# DICK'S SPORTING GOODS HOUSE OF SPORT JSP24-31

# PLAN REVIEW CENTER REPORT Planning Review

Dick's Sporting Goods JSP24-31 March 14, 2025

Revised Preliminary Site Plan and Special Land Use

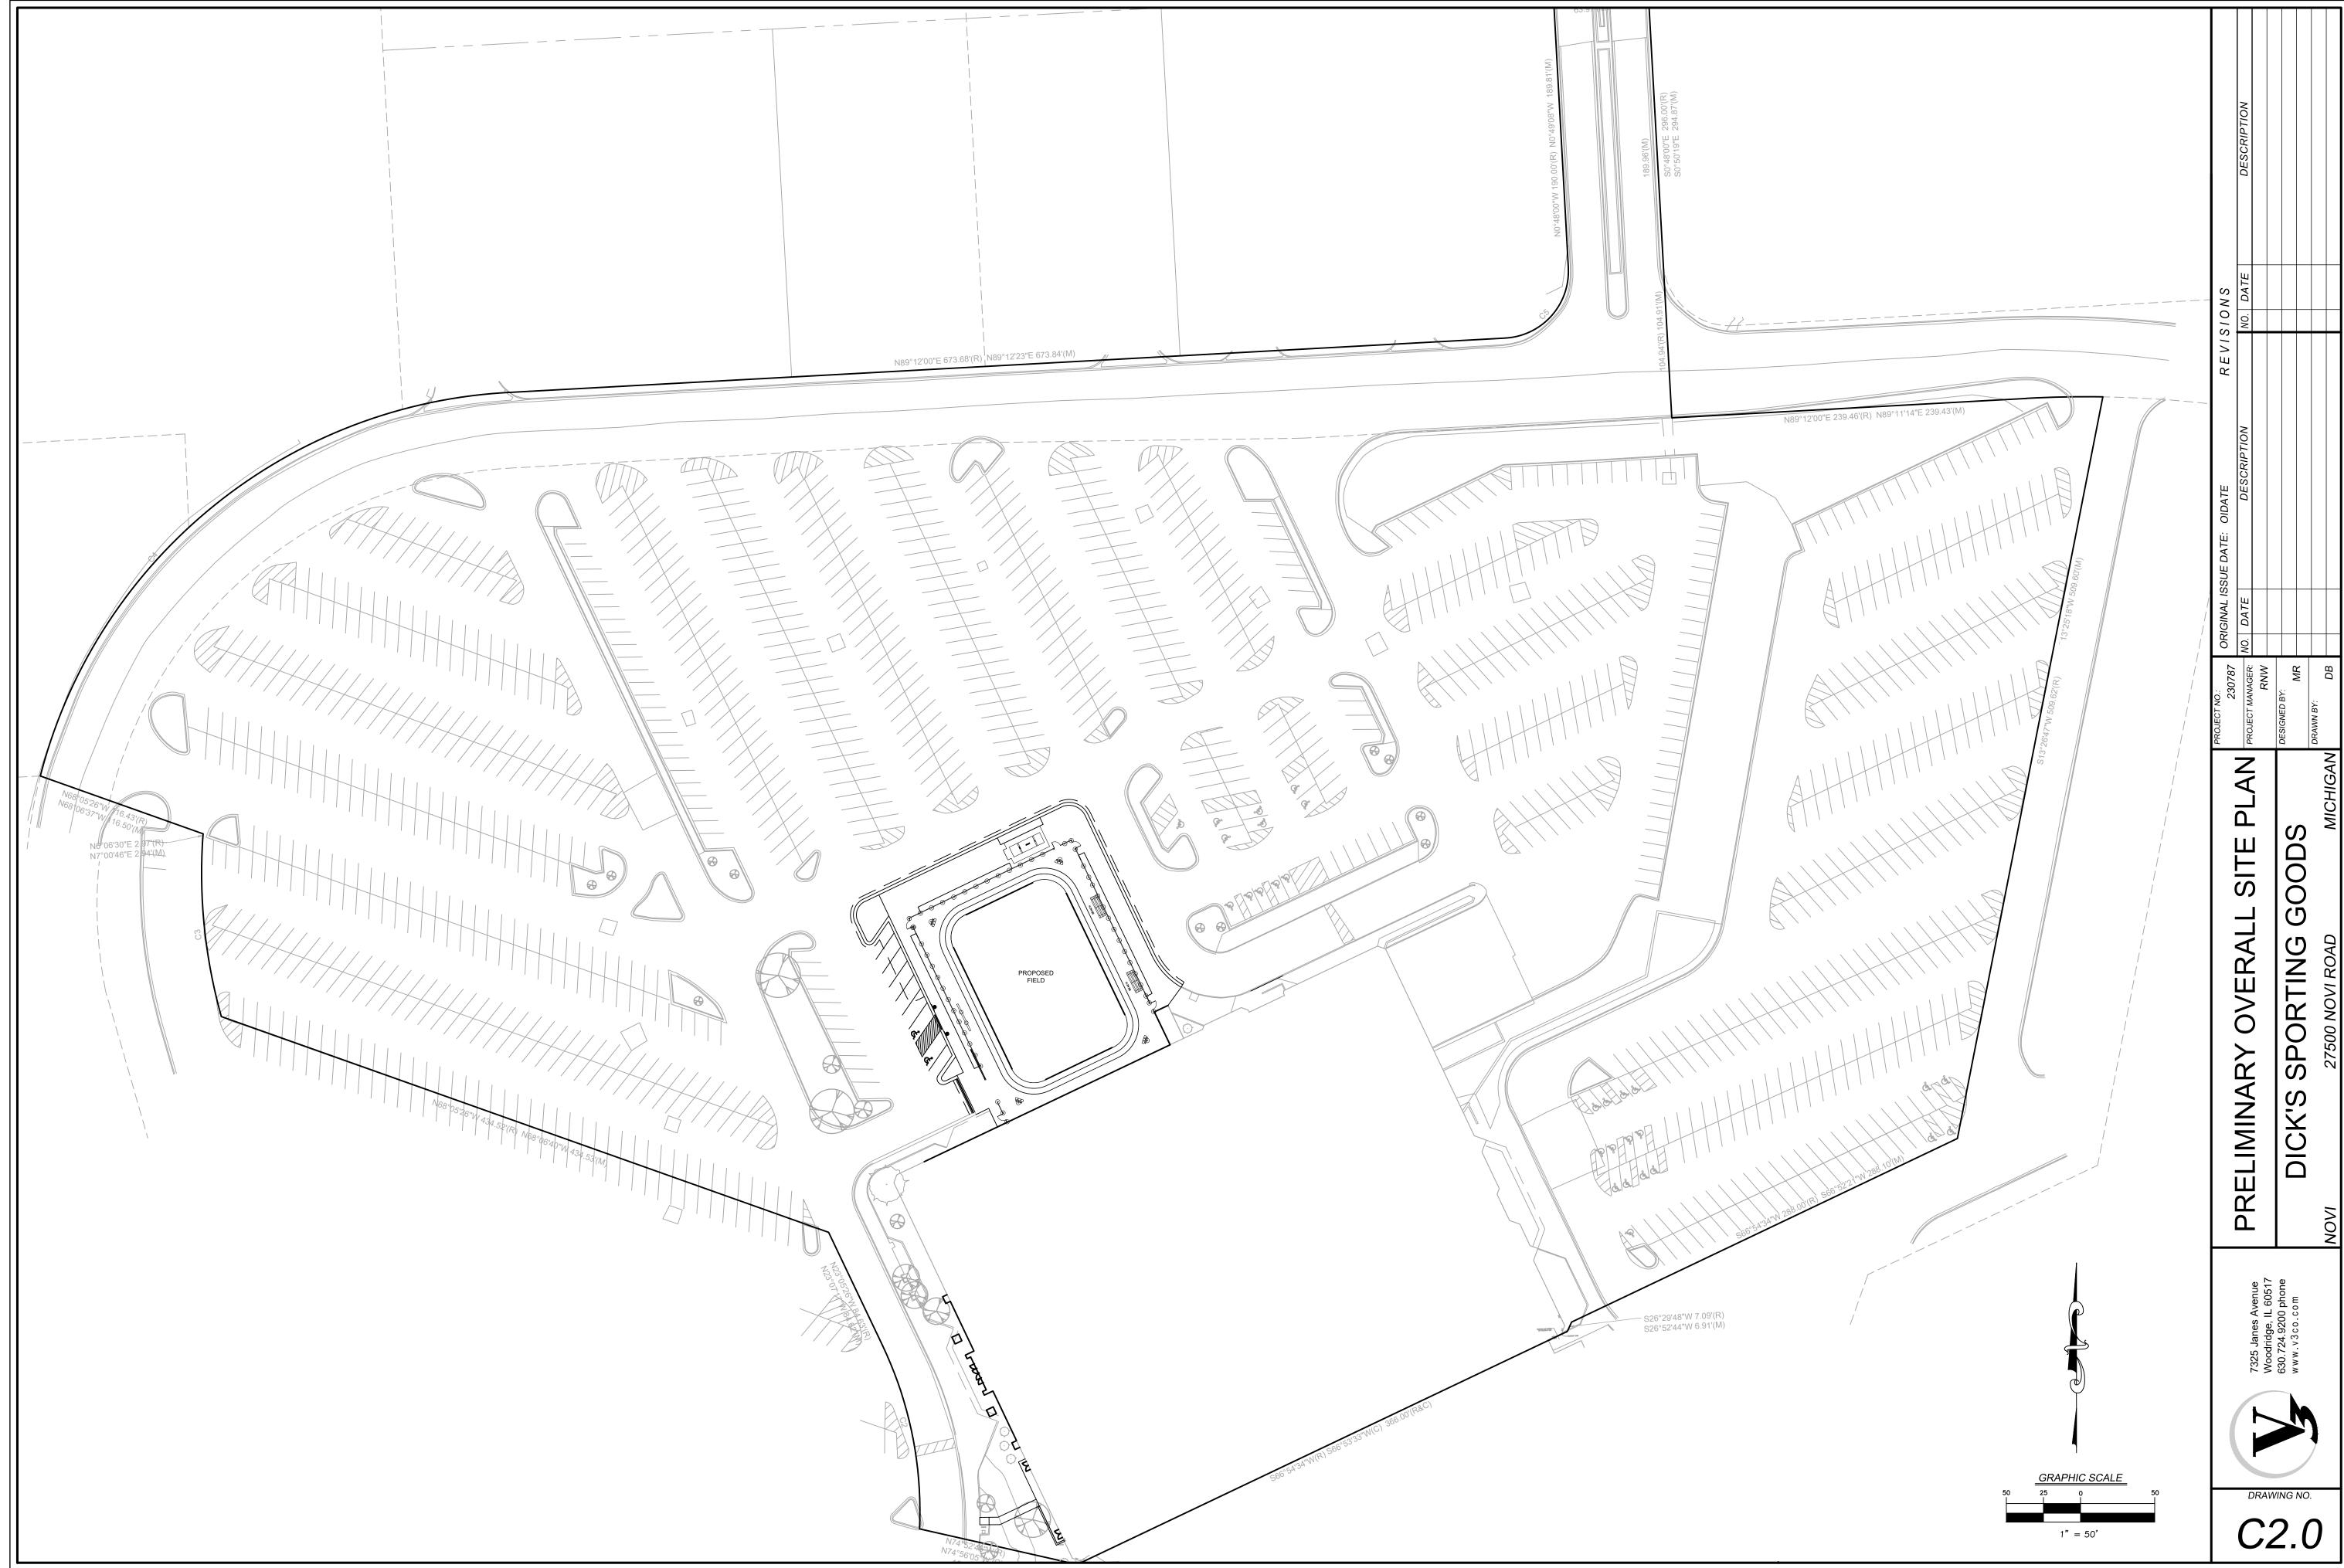
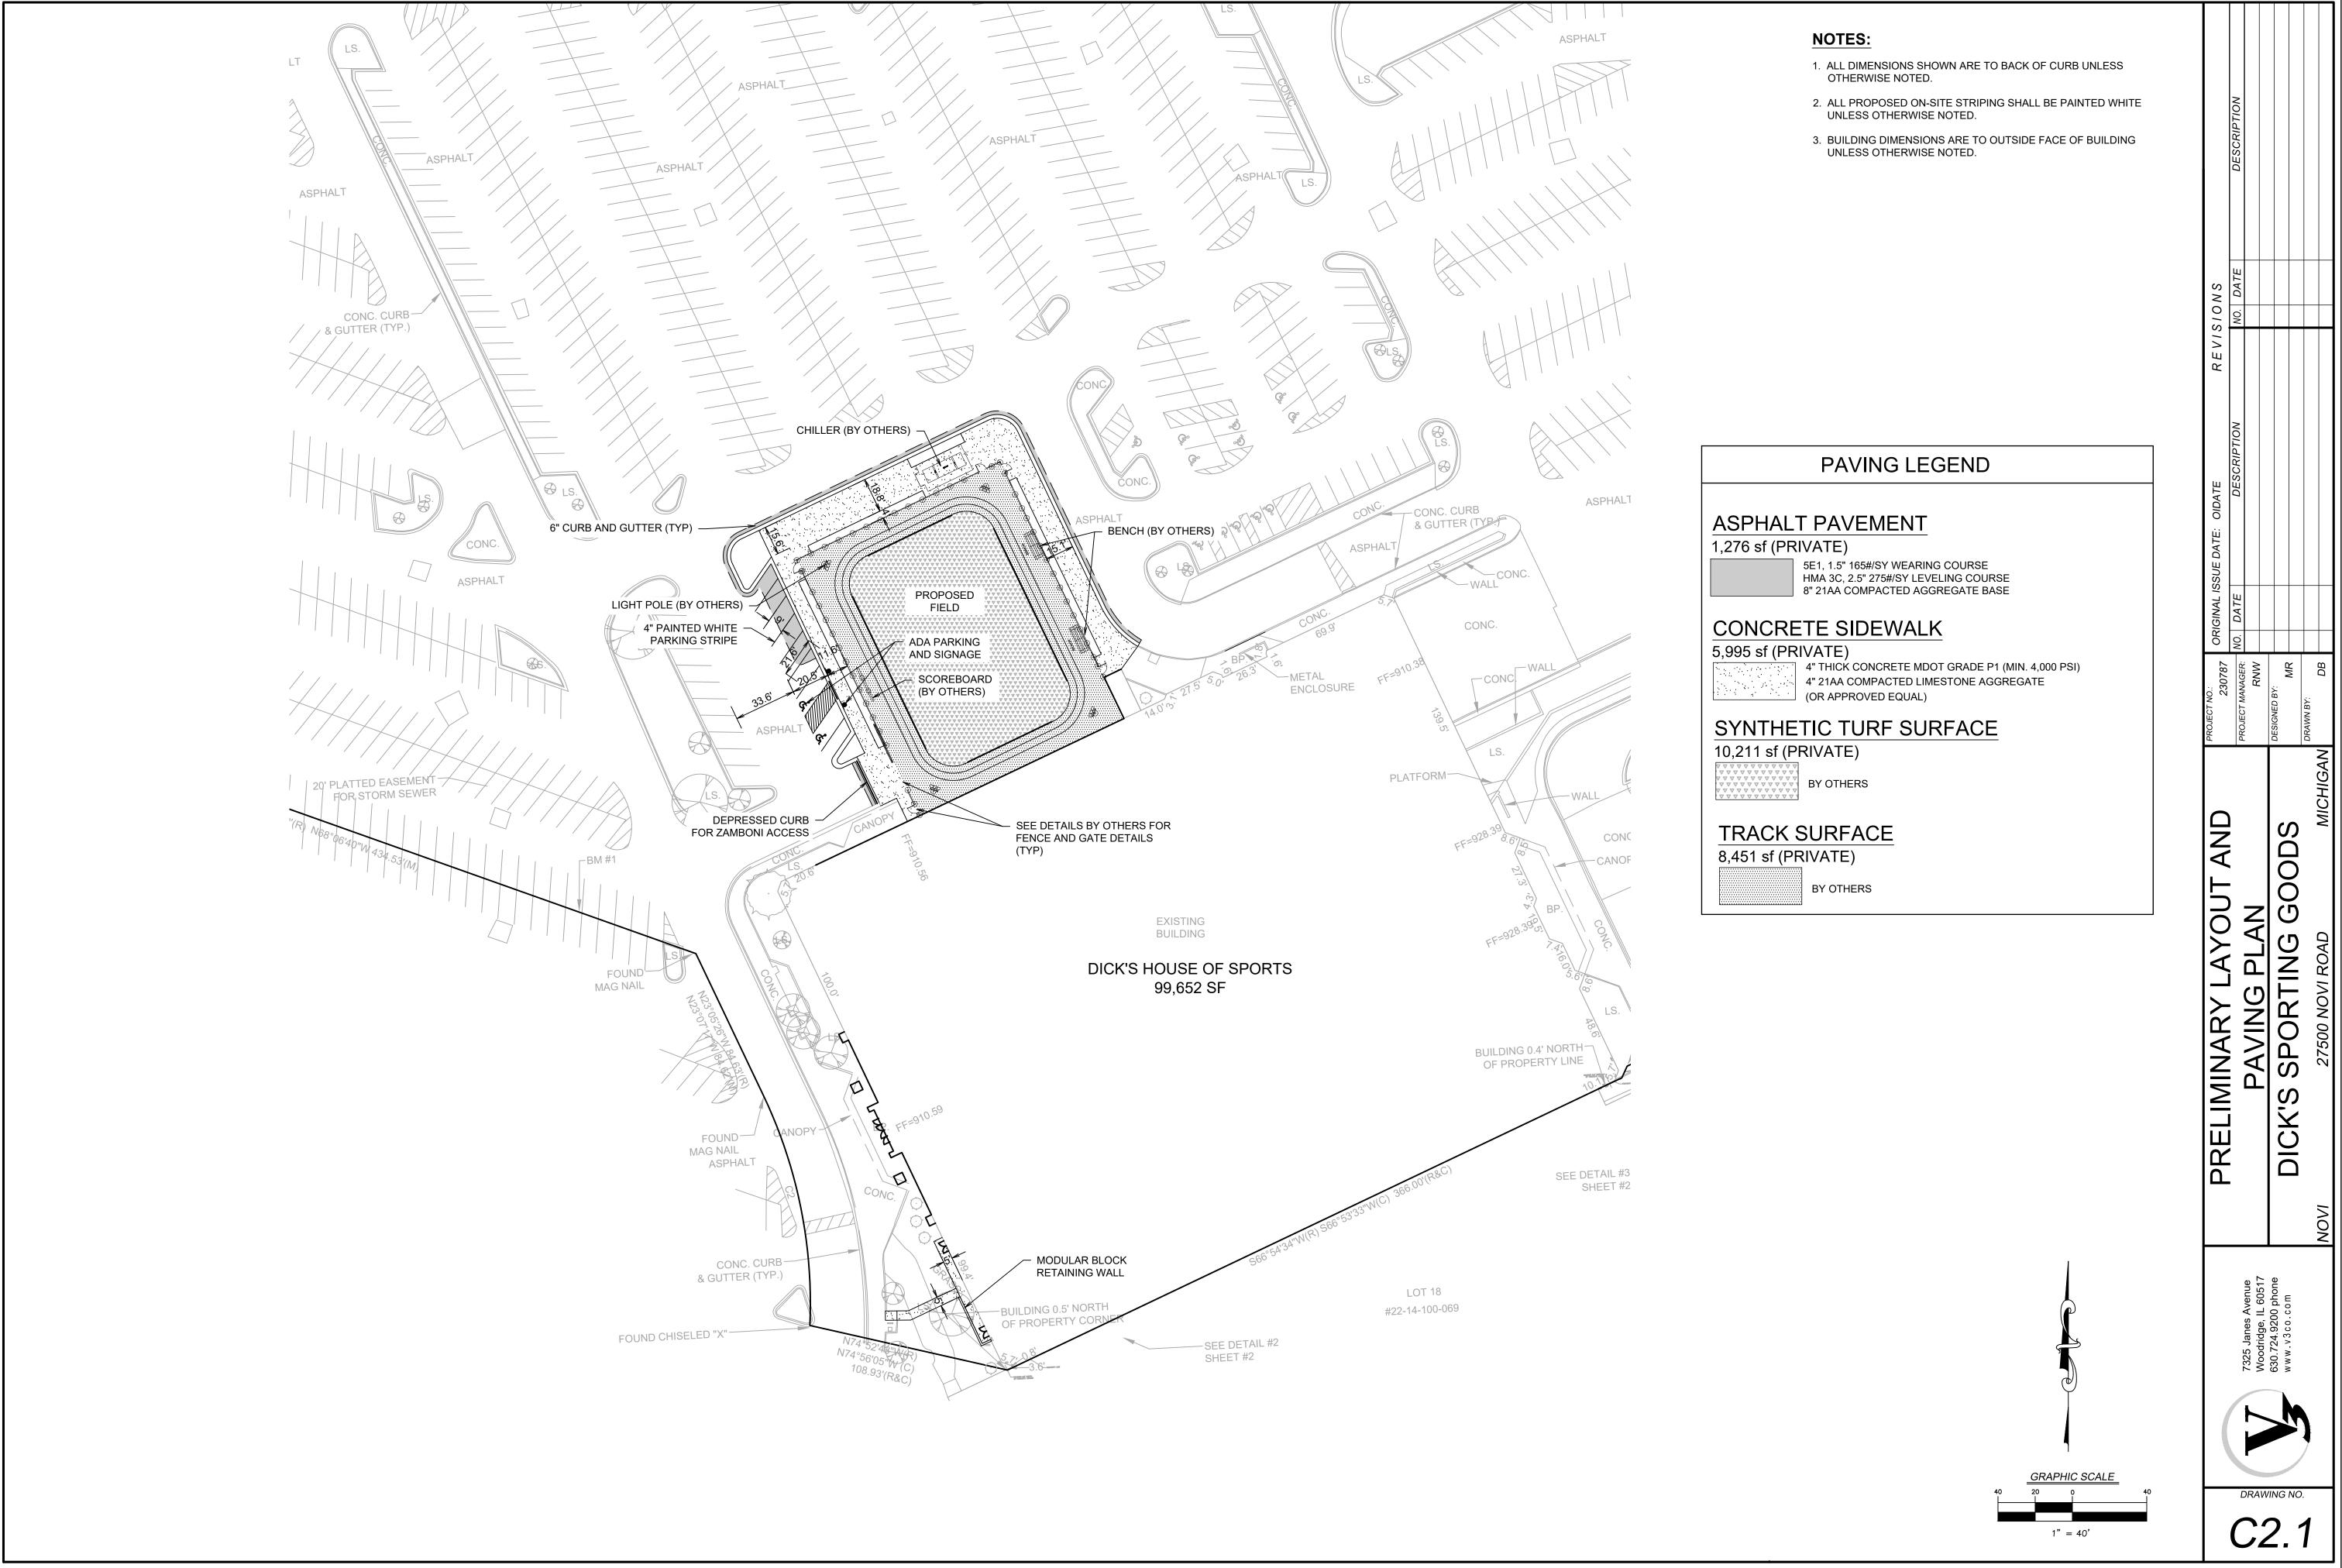
Comment 15: Sheet C4.0 indicates 18' light poles, lighting specifications and response letter indicate

Response:
